**ADDENDUM NUMBER 1 ON INVITATION TO BID ITB21KO-121**

**TITLE:** Thermal Utility System Improvements

ITB21KO-121  
UF-623B Thermal Utility System Improvements  
Questions and Answers

**STREET AND AREA LIGHTING**

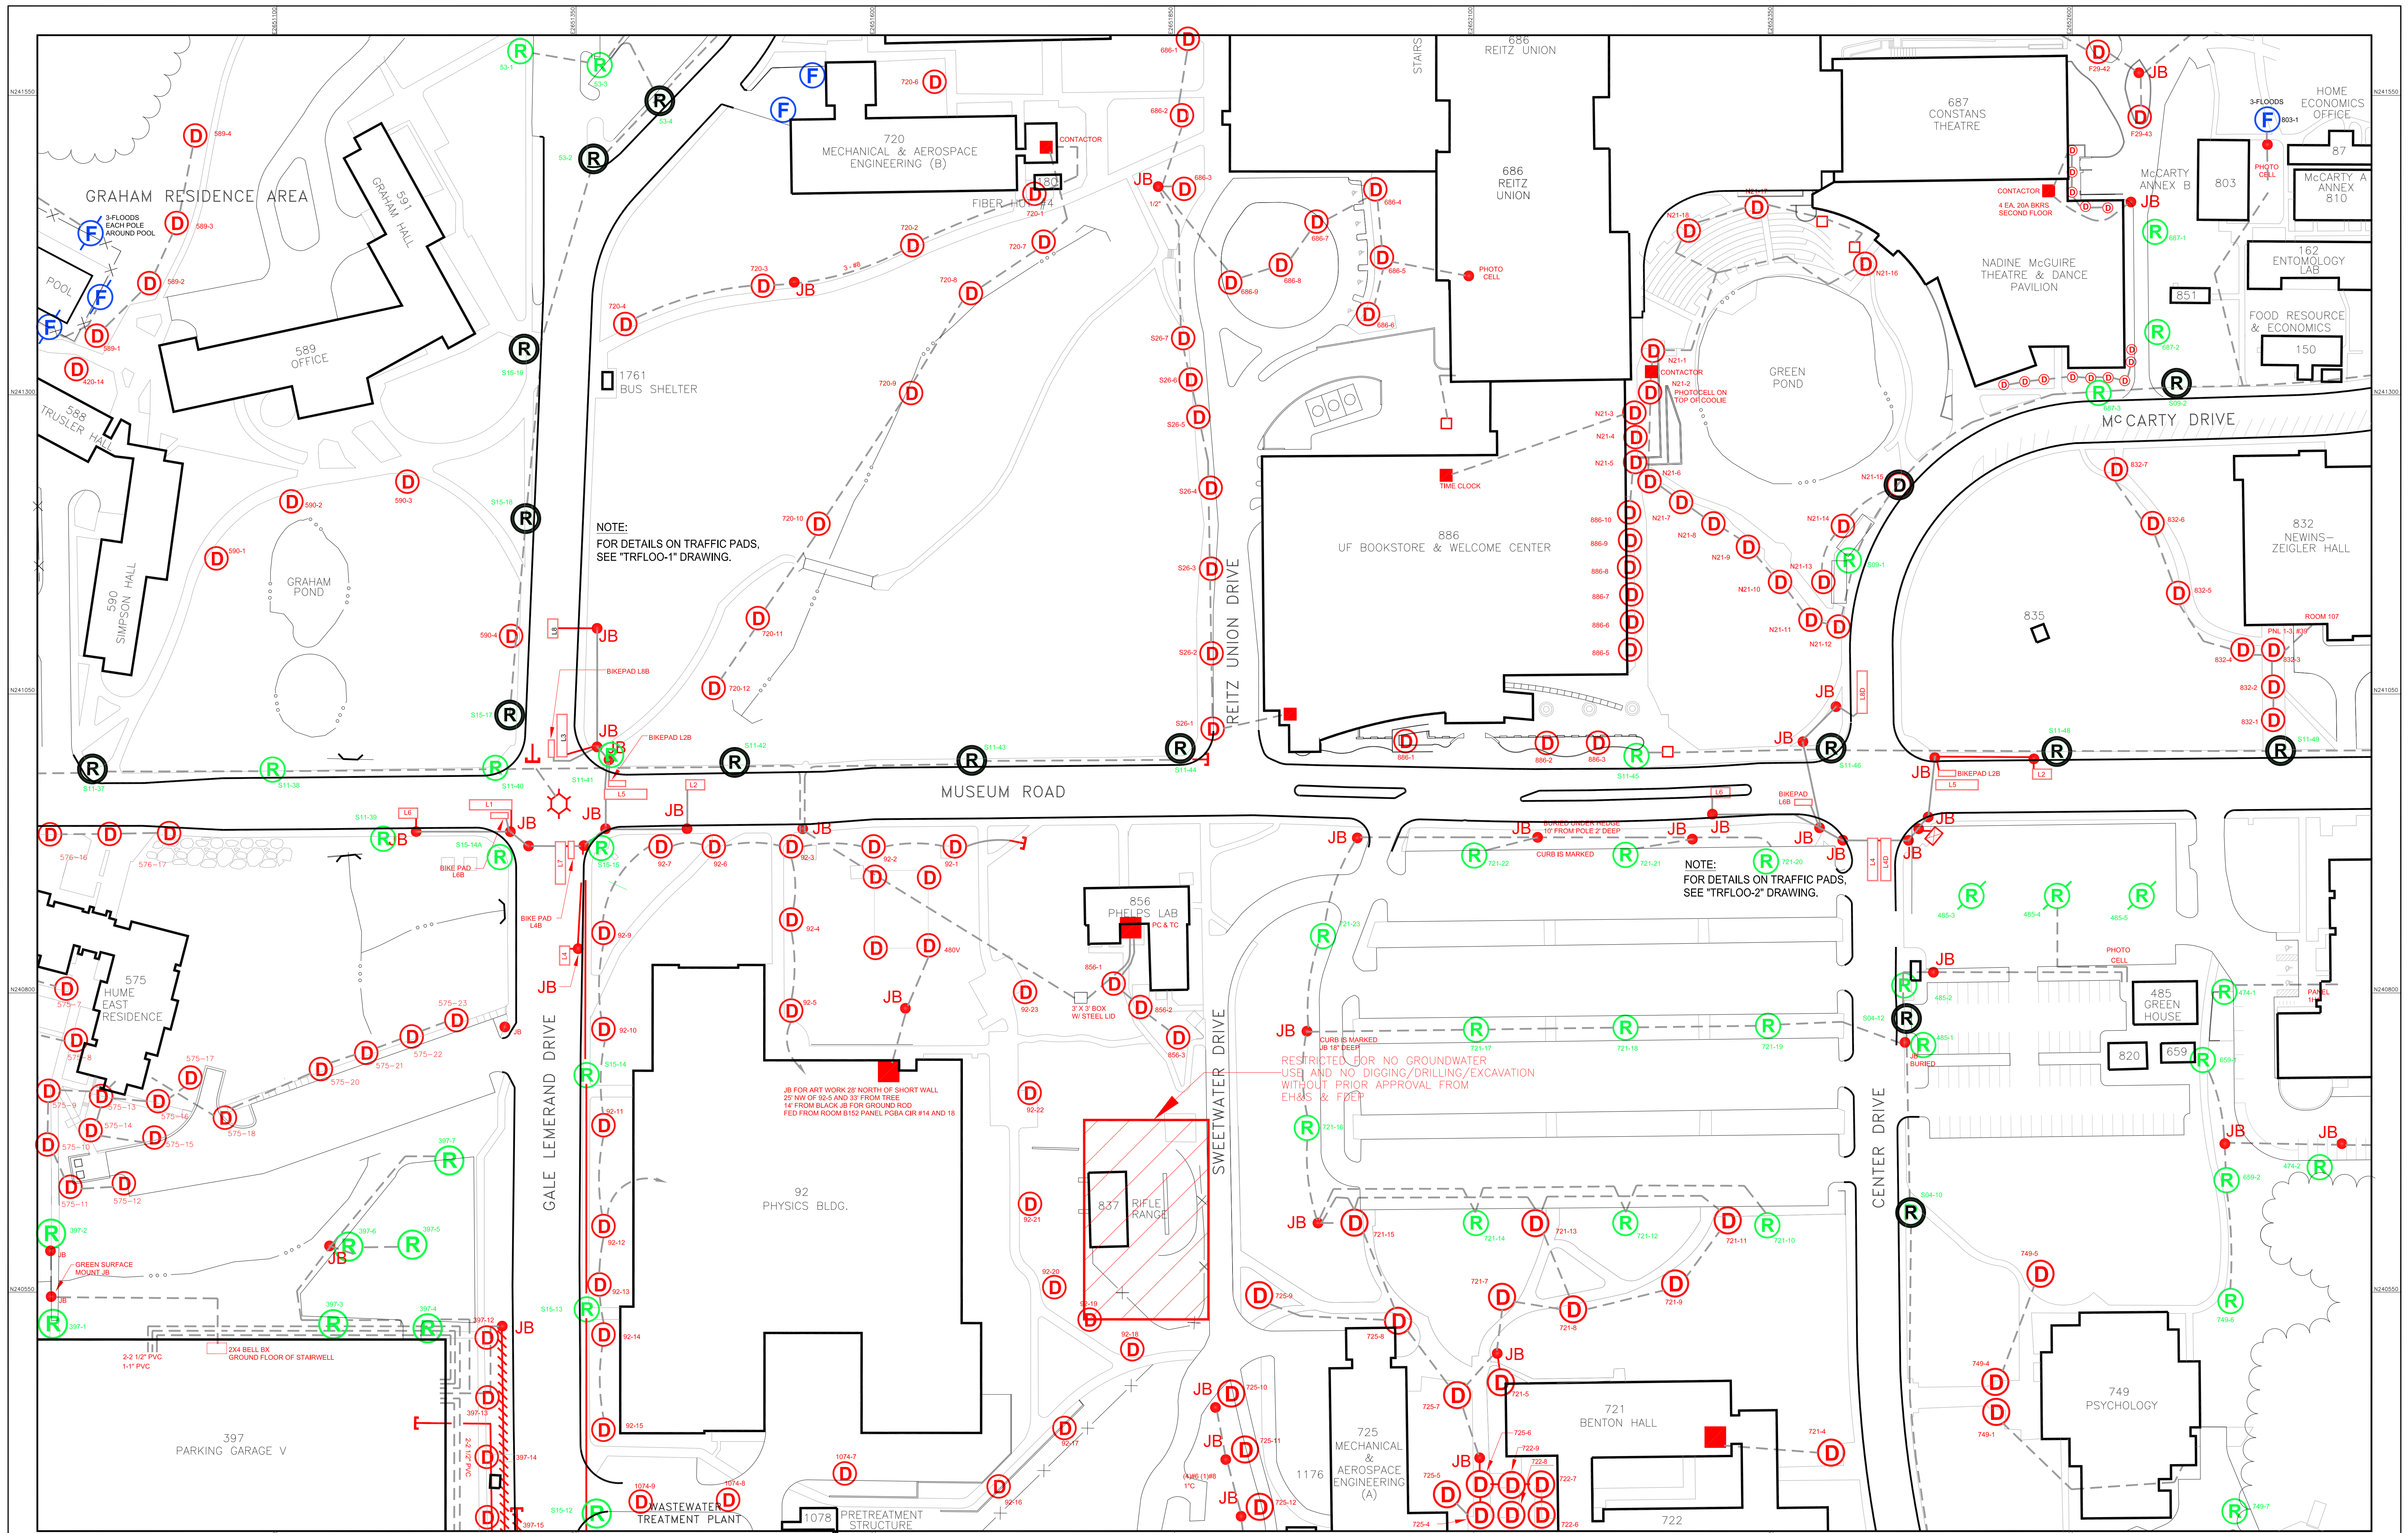
Q20. One of the pole lights to be relocated on 1-CU141 appear to be HID. The wattage of the lamps, the length of the lighting circuit, the number of poles on the lighting circuit and the voltage all impact the size of the lighting circuit. Is any of this information available?

A20. See Attachment named "Street and Lighting Area Map".
